**Inspection Report
2-4 Cunningham Street, Haymarket**

Council Investigation Officer Inspection and Recommendation Report; Clause 17(2) Part 8 of Schedule 5 of the Environmental Planning and Assessment Act 1979 (the Act)

**Re: INSPECTION REPORT
'APX HOTELS APARTMENTS – APX WORLD SQUARE'
2 CUNNINGHAM STREET, HAYMARKET ("the premises")**

**Re: INSPECTION REPORT
ASPECT
2-4 CUNNINGHAM STREET HAYMARKET ("the premises")**

Figure 1

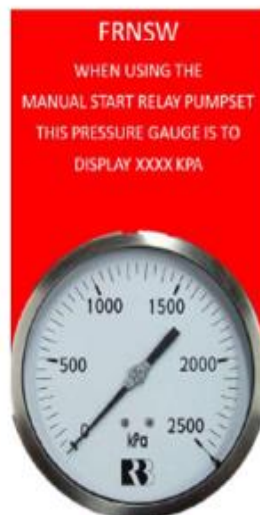
FRNSW position statement '[FRNSW pump performance for high rise buildings](#)' states, the fire hydrant system is to be designed for a 'Boost Pressure' of 950 kPa being input into the fire brigade booster connection from a standard FRNSW pumper, for buildings having an effective height greater than 50 m and requiring a fire brigade relay pump. FRNSW are of the opinion that the boost pressure signage should state, BOOST PRESSURE 950kPa and the relay pump be modified to ensure correct operational pressures.

Additional signage should be installed along with a 150mm pressure gauge similar to *Figure 1*, to advise firefighters of the required pressure at the RELAY PUMP discharge.
